Re: Connecticut Siting Council Docket 463
American Towers, LLC (ATC) & New Cingular Wireless PCS, LLC (AT&T)
Proposed Wireless Telecommunications Tower Facility
351A Boston Post Road, Connecticut

APPLICATION OF AMERICAN TOWERS LLC (ATC)
AND NEW CINGULAR WIRELESS PCS, LLC (AT&T)
FOR A CERTIFICATE OF ENVIRONMENTAL
COMPATIBILITY AND PUBLIC NEED FOR THE
CONSTRUCTION, MAINTENANCE AND OPERATION
OF A TELECOMMUNICATIONS TOWER FACILITY IN
EAST LYME, CONNECTICUT

DOCKET NO. 463

RESPONSES TO CSC INTERROGATORIES

CT1345B#8
 171 Boston Post Rd
 East Lyme, CT 06333
 Lat: 41 22 01 N
 Long: 72 12 58.8 W
 Antenna Ht: 199' AGL
 GE: 42.0' AMSL

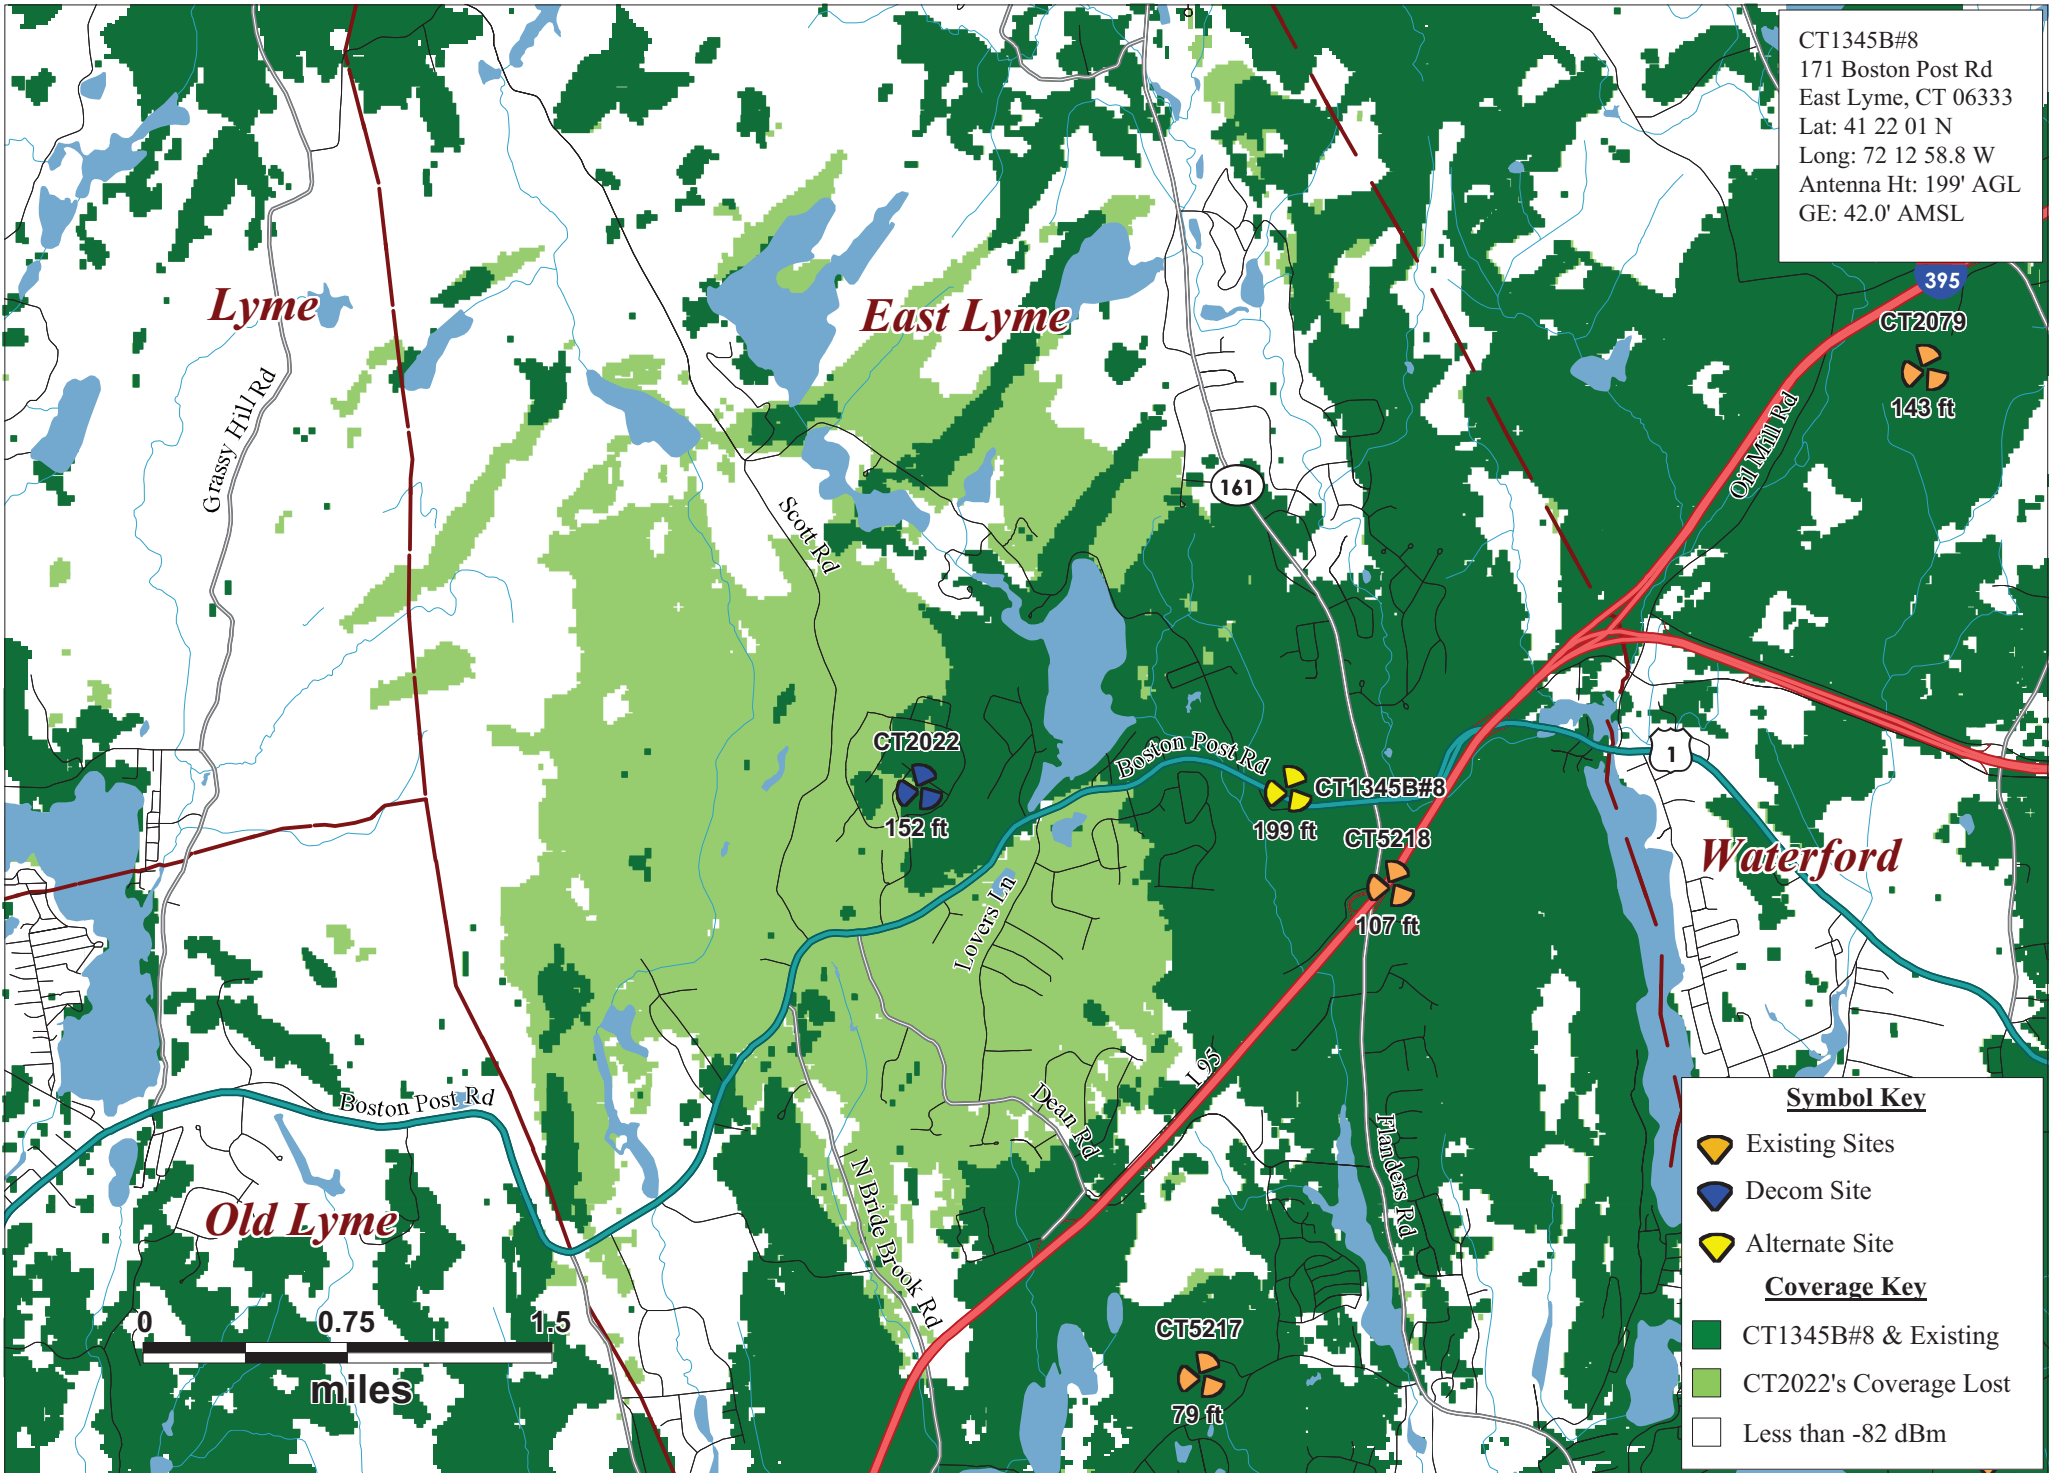
- b) For site #8 , provide a coverage plot for the height examined. What height would be required to provide adequate service?
 - c) For site #9, what height is required to provide adequate service? With whom did the Applicant discuss potential tower availability? What was the specific reason given as to why this existing facility is not available for colocation?

- b) #8-This location is outside the coverage area and at a low ground elevation. To provide adequate service, a tower at this location would have to be well in excess of the height requiring lighting, so it was rejected for further acquisition efforts. The current tower at this location is approximately 75 feet from Flanders School. In addition, most of its coverage would duplicate current coverage from other AT&T sites. See plot in attachment C.

CT1345B#18
 440 Boston Post Rd
 East Lyme, CT 06333
 Lat: 41 21 14.8 N
 Long: 72 15 06 W
 Antenna Ht: 45' AGL
 GE: 207.0' AMSL

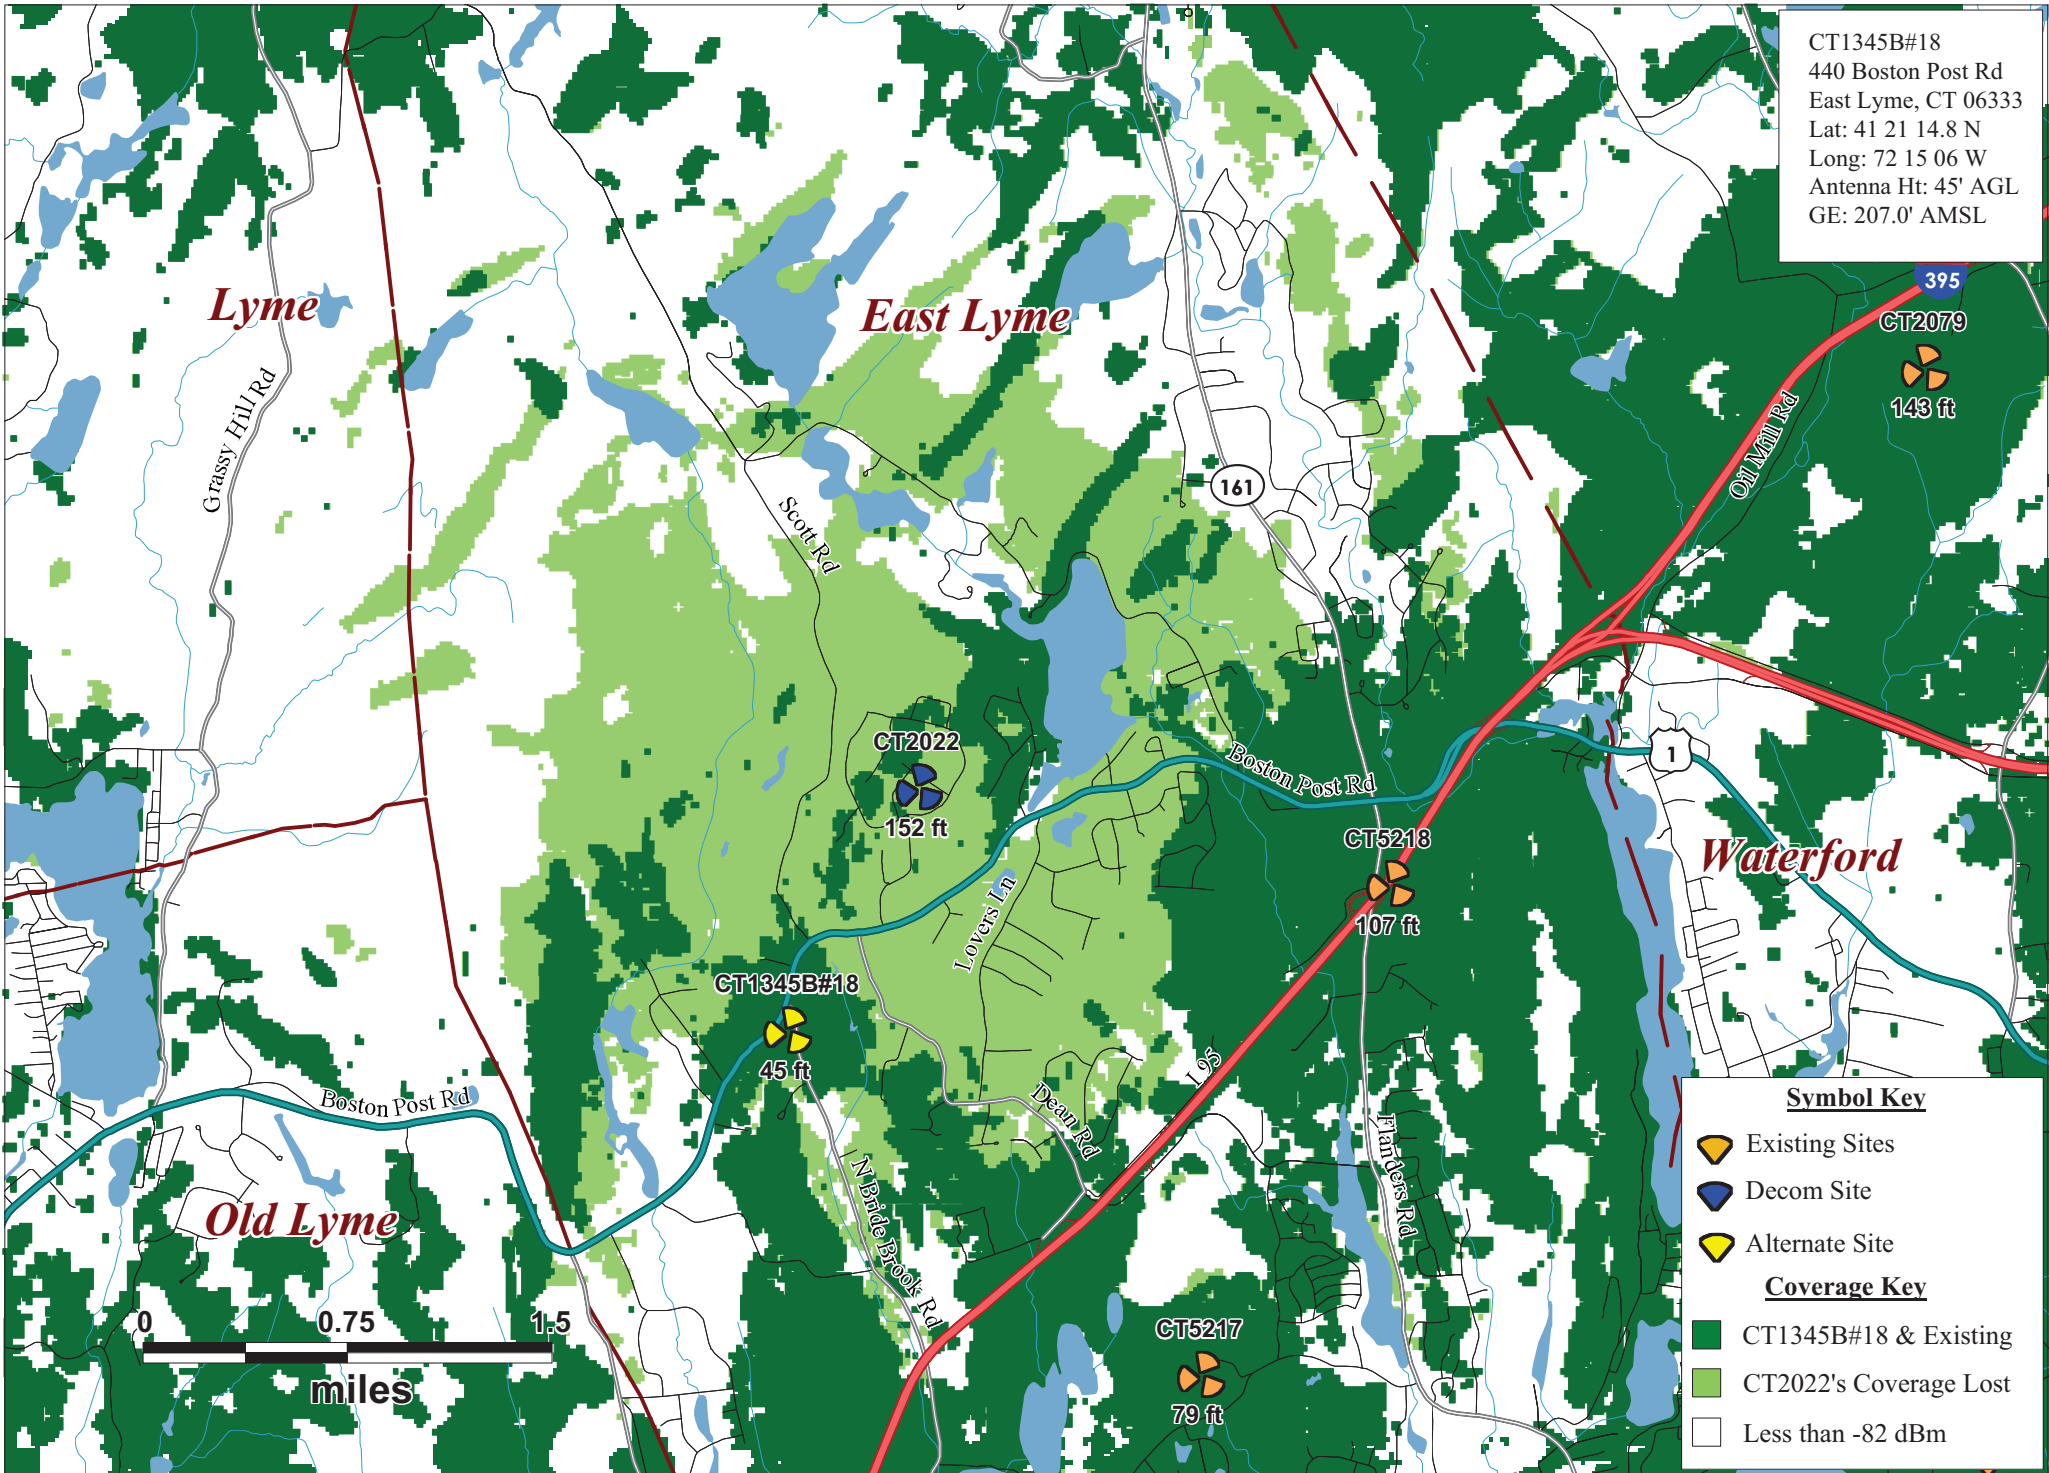
- d) For site #15, what entity is proposing a tower in this location? What tower height is necessary to provide adequate service from this location?
 - e) For site #18, provide a coverage plot for the height examined.

- e) #18-This location is a water tank approximately 45' tall, so the coverage analysis was done at that height. See plot in attachment C.
- f) #24-This location is outside the coverage area. To provide service, a tower at this location would have to be well in excess of the height requiring lighting, so it was rejected for further acquisition efforts. See plot in attachment C.

CT2022 vs. CT1345B#24 Added
 850 MHz UMTS Coverage

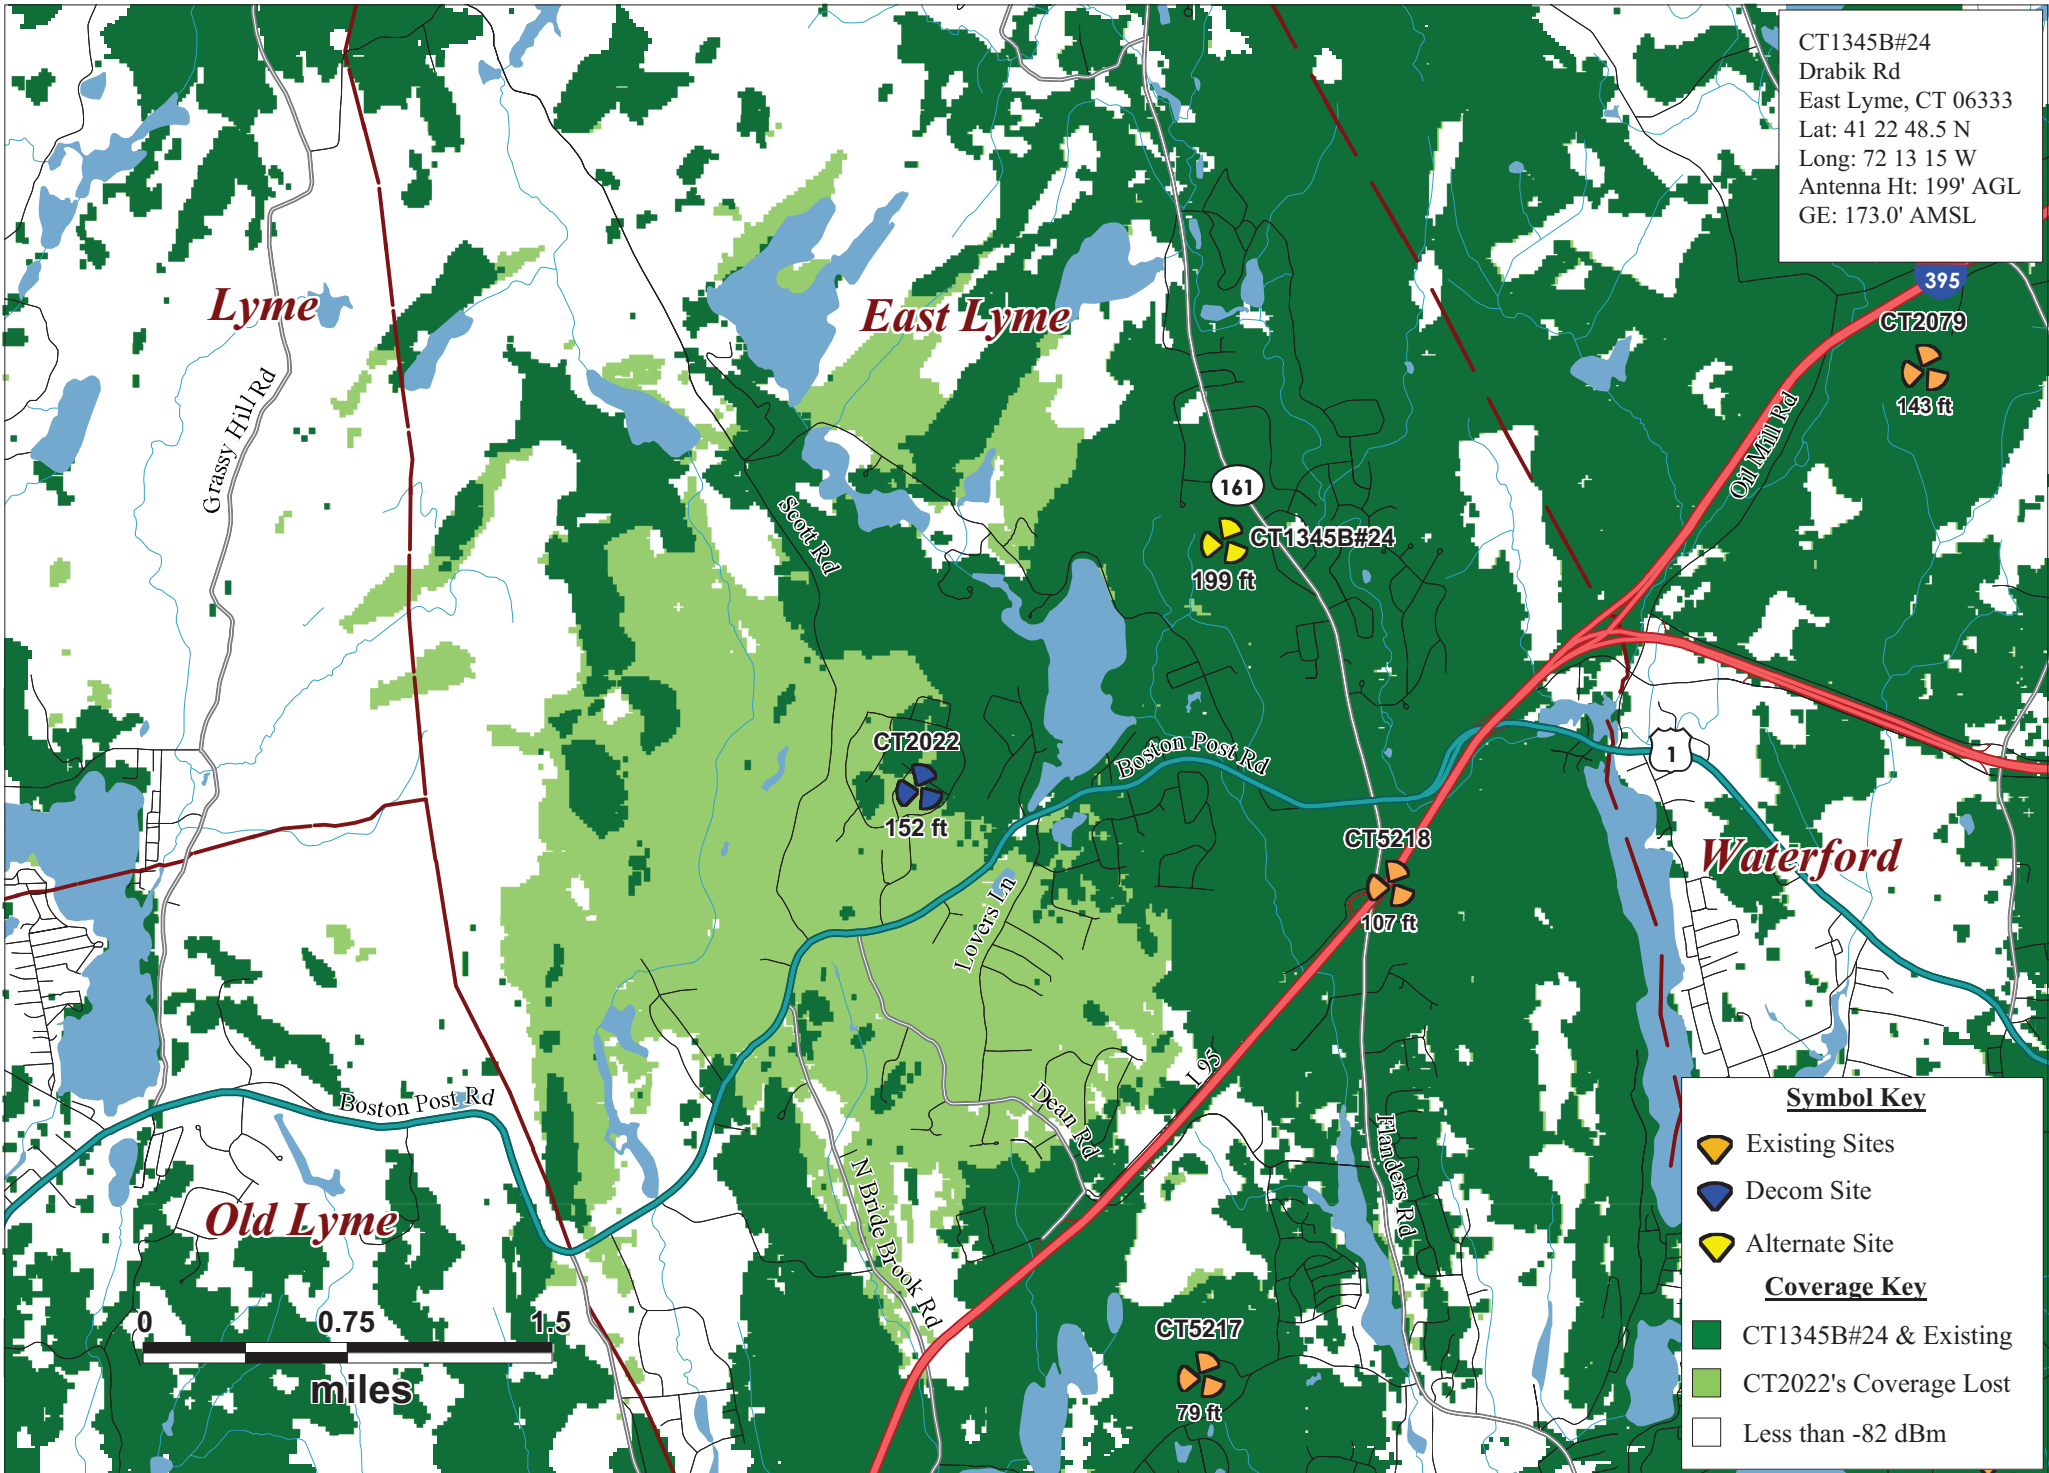
- f) For site #24, provide a coverage plot for the height examined.
- 18A. All of these sites were analyzed up to and including 199' above ground level. That height was chosen as a maximum height based on a combination of FAA requirements for tower-top lighting on towers 200 feet or more above ground level and the Applicants' understanding of Town of East Lyme perspectives on this tower relocation project.

1 PARTIAL SITE PLAN
SCALE: 1" = 30'

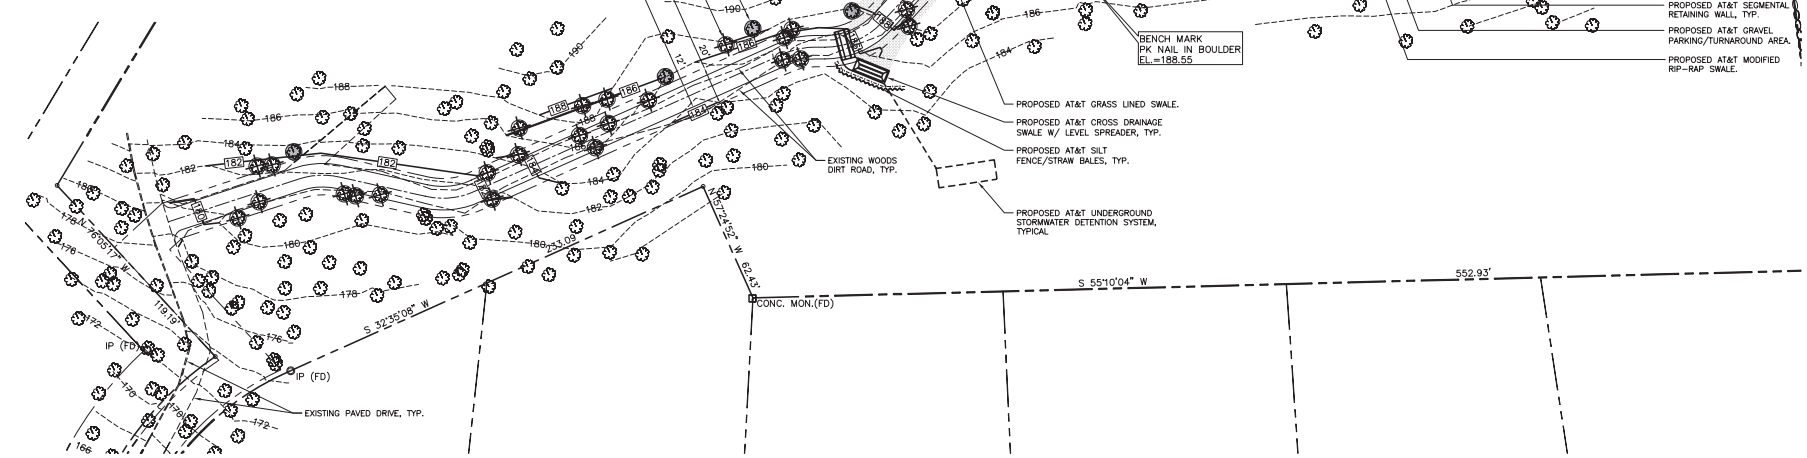
21. Has a site plan been developed showing site topography, areas of clearing, grading, and storm water control features? If so, please provide.
- 21A. Please see attached site grading and drainage control plan annexed in Attachment D.
22. Provide an 8.5" x 11" aerial photograph that shows both the existing tower and the proposed site.
- 22.A Please see attached Aerial photograph showing both existing tower location and proposed site annexed in Attachment E.
